SUBJECT: RCRA Facility Investigation / Remedial Investigation Work Plan Addendum for the D-Area Groundwater Operable Unit (D-Area Upgradient Sources) (U) (SRNS-RP-2024-00312, Revision 1 Redline, July 2024) and Savannah River Site's Responses to the Regulatory Comments on the Revision 0 Document, SEMS Number: 63

SRS Responses to the US Environmental Protection Agency's Comments on the RCRA Facility Investigation/Remedial Investigation Work Plan Addendum for the D-Area Groundwater Operable Unit (D-Area Upgradient Sources) (U), (SRNS-RP-2024-00312, Revision 0, April 2024),

SRS Responses to the South Carolina Department of Environmental Services' Comments on the RCRA Facility Investigation / Remedial Investigation Work Plan Addendum for the D-Area Groundwater Operable Unit (D-Area Upgradient Sources) (U), SEMS Number: 63
(SRNS-RP-2024-00312, Revision 0, April 2024)
Comments received June 3, 2024

Revised Figure 1. D-Area 411-D Fire-Fighting Training Area (FFTA)

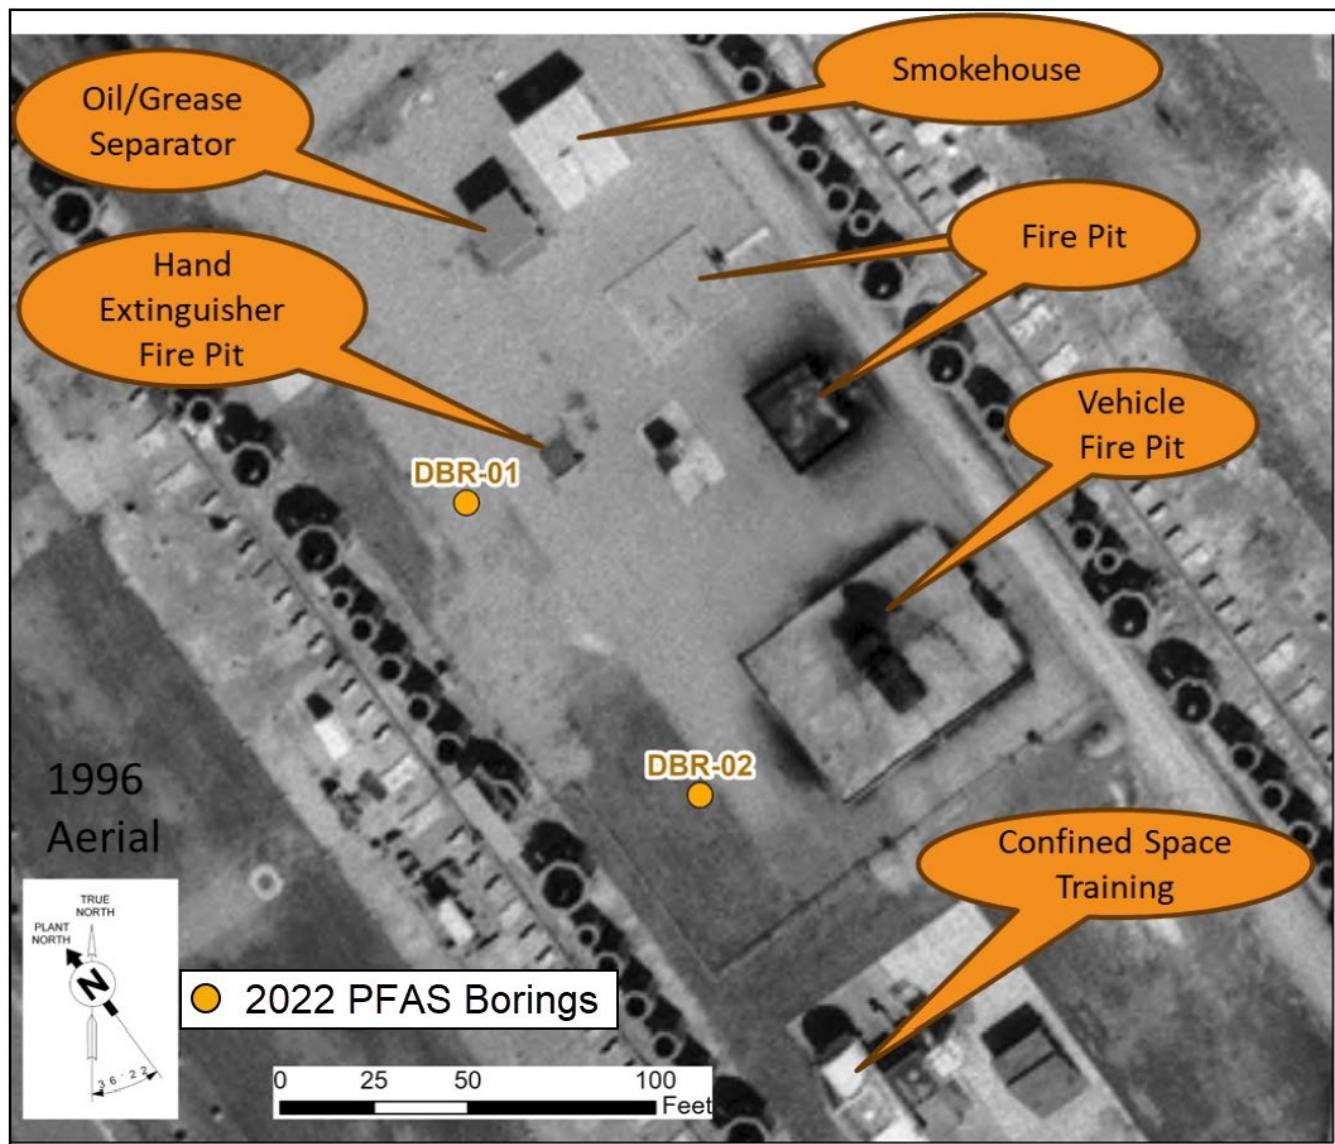
3. **Figure 1, D-Area 411-1D Fire-Fighting Training Area (FFTA), PDF Page 49 of 100:** Figure 5, D-Area FFTA 2022 Previous PFAS Soil Borings, identifies borings DBR-01 and DBR-02 as 2022 PFAS Soil Borings; however, they are not defined as such on Figure 1. Please revise Figure 1 to identify DBR-01 and DBR-02 as 2022 PFAS Soil Borings.

The Rev. 1 RFI/RI Work Plan Addendum will include a revised Figure 1, D-Area 411-1D Fire-Fighting Training Area (FFTA) (see attached), that includes a legend showing DBR-01 and DBR-02 as 2022 PFAS Soil Borings.

Revised Figure 2. D-Area 715-D Gasoline Station Area

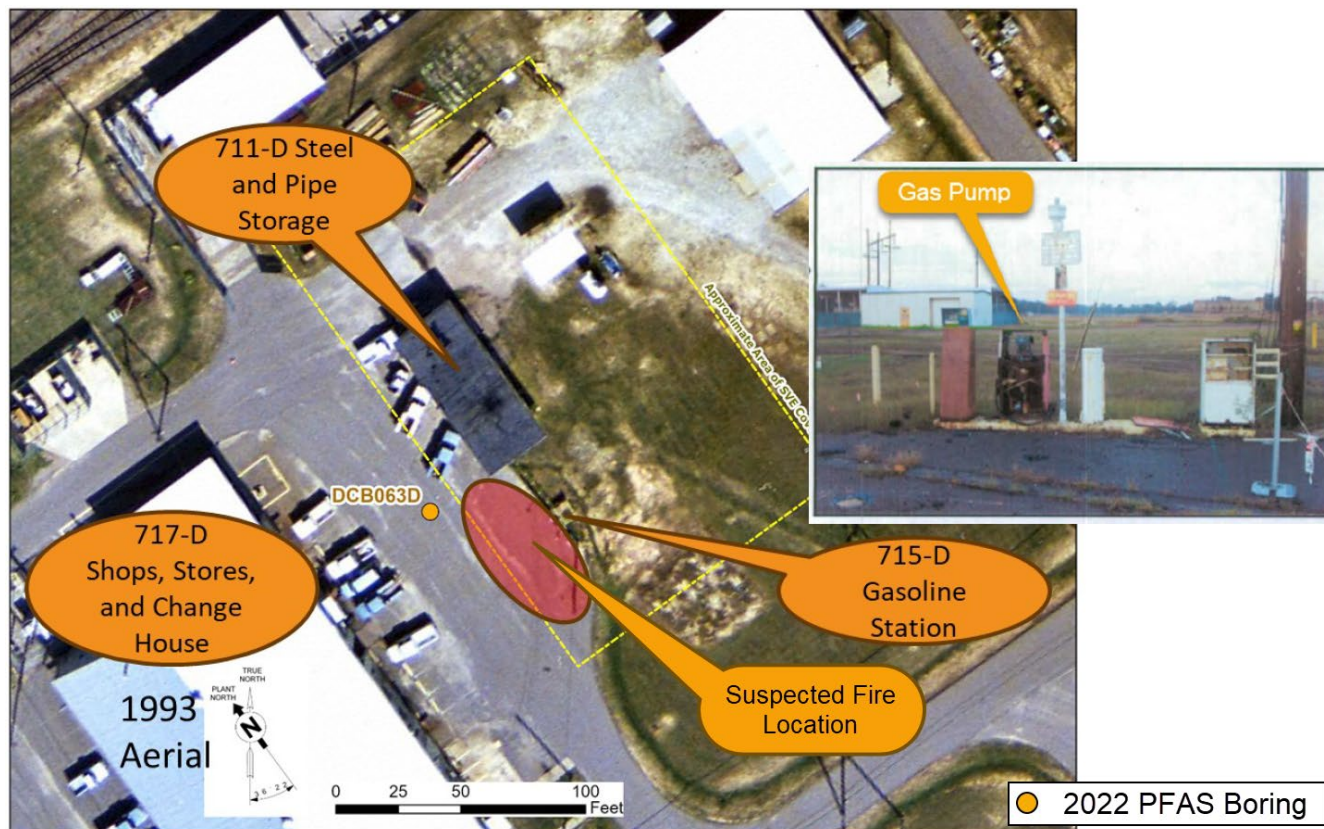
4. **Figure 2, D-Area 715-D Gasoline Station Area, PDF Page 51 of 100:** The symbol used to represent boring DCB063D and the red oval shape are not defined on the figure. Please revise Figure 2 to include definitions for the symbol representing boring DCB063D and the red oval shape.

The red oval in Figure 2, D-Area 715-D Gasoline Station Area, is the area where the fuel fire was suspected to occur. The Rev 1 RFI/RI Work Plan Addendum will include an updated figure with a callout label, "Suspected Fire Location" for the red oval area and a legend for the symbol representing boring DCB063D.

Revised Figure 12. Proposed 715-D Gasoline Station Area Sample Locations

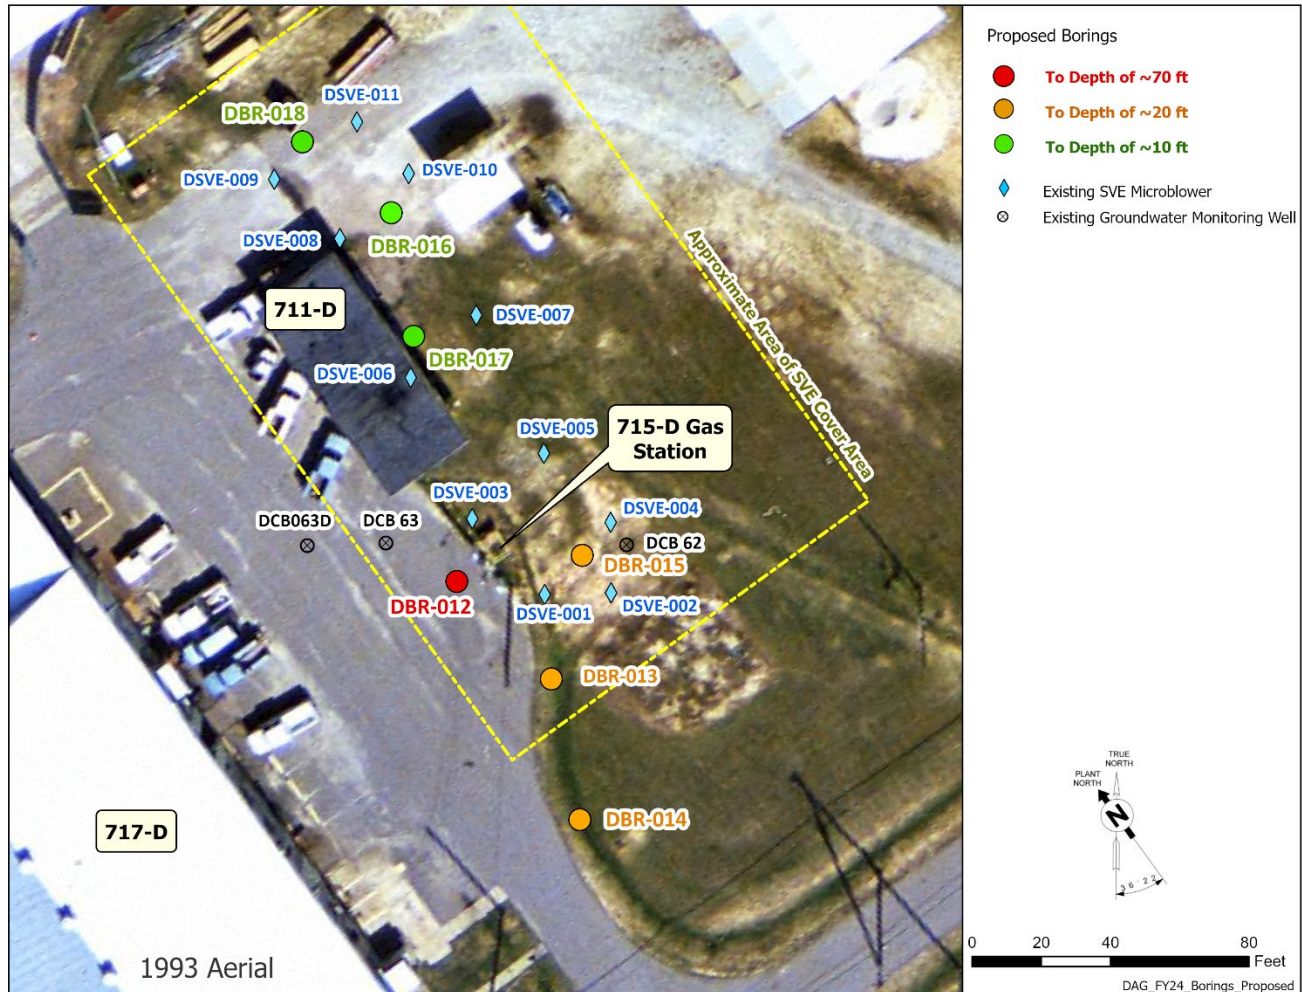
2. The proposed sample locations at the 715-D Gasoline Station Area appear insufficient to determine whether tetrachloroethylene (PCE) contamination has been successfully remediated in soil to levels below the threshold limit of 20 micrograms per kilogram ($\mu\text{g}/\text{Kg}$). As such, is it unclear whether the objectives listed in Section 3.1, Objectives will be achieved. Specifically, there are only three intervals proposed for sampling and analysis for volatile organic compounds (VOCs) in each of the five proposed borings. According to Table 5, Proposed DSVE VOC Soil Samples, the 5-6 foot interval below ground surface will not be sampled. Additionally, it is unclear why the borings are not located near the soil vapor extraction (SVE) units where PCE and trichloroethylene (TCE) concentrations were historically the highest (e.g., DSVE 006 and DSVE 008 and DSVE 009). According to Figure 12, Proposed 715-D Gasoline Station Area Sample Locations, soil boring DBR-016 is proposed near DSVE-008; however, a soil boring is not proposed near DSVE-006 or DSVE-009. Thus, it unclear how it will be determined whether PCE contamination has been successfully remediated. Please revise the RFI/RIWP to propose soil sampling from the 5-6 foot interval and to propose additional soil borings near DSVE-006 and DSVE-009.

SRS agrees to collect VOC soil samples in the 5-6 ft sections at borings DBR-012, DBR-015, and DBR-016. Additionally, SRS will conduct VOC soil sampling at borings adjacent to the SVE units DSVE-006 (DBR-017) and SVE unit DSVE-009 (DBR-018). Both borings will include sample intervals of 1-2 ft, 3-4 ft, 5-6 ft, and 8-10 ft bgs. About 4 ft will be added to these intervals to account for the SVE soil cover thickness, and sampling will begin at the original ground surface. See revised Figure 12 for the proposed locations. These two additional borings will also include PFAS soil sampling. Additional duplicate and split samples will be included. Text within section 5.2, VOC Soil Samples will be updated as follows:

Tables 1, 4, 5, and Figure 12 (see attached) will be updated to reflect the additional sample

interval and two additional borings (DBR-017 and DBR-018).
